PLANNING COMMISSION STAFF REPORT

FOR CONSIDERATION BY PLANNING COMMISSION ON OCTOBER 22, 2024

WILLOW GROVE SUBDIVISION – DESIGN PLAN

Re: Willow Grove Subdivision – Design Plan Review

SITE PLAN LAYOUT
WILLOW GROVE
BATAVIA TOWNSHIP
CLERMONT COUNTY, OHIO

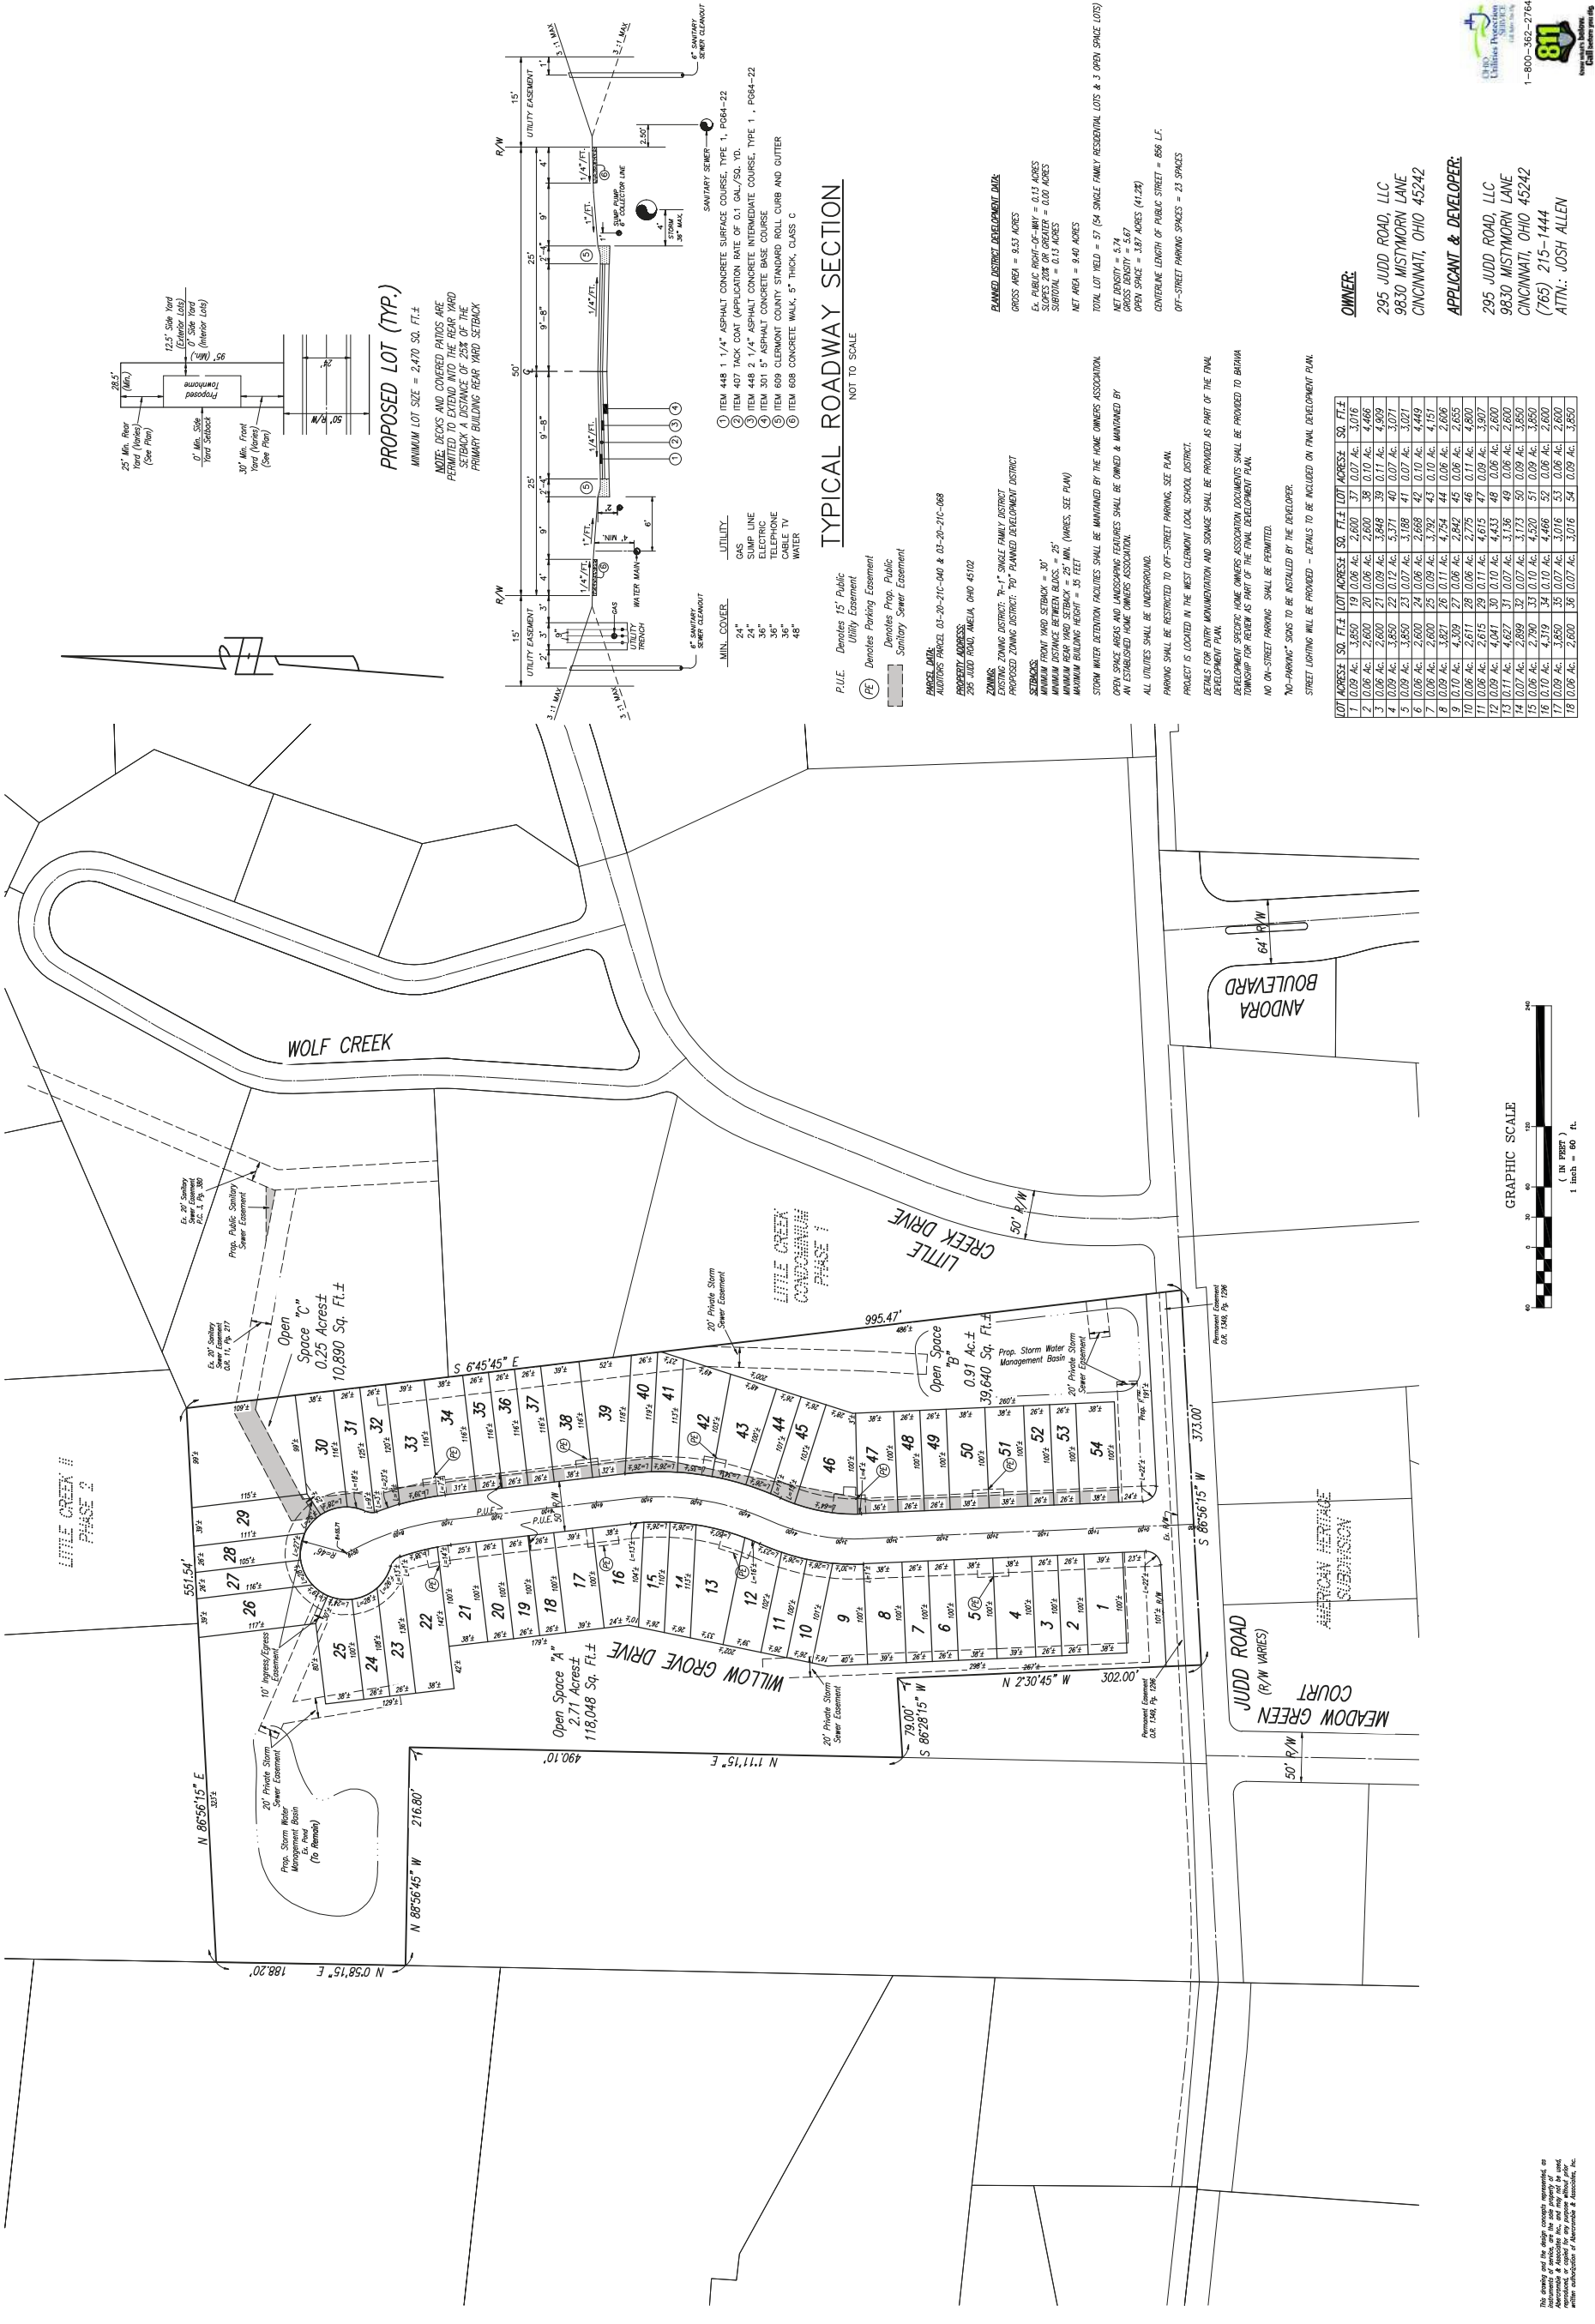
1. Include comprehensive area table of area in lots, right-of-way. Open space is there but not what is mentioned.
2. Is there a min lot area or lot width?
3. The Township is requiring berms along Judd Road, these are not shown on the design plan.
4. Will there be any phasing?
5. Change zoning wording on sheet C 101A.
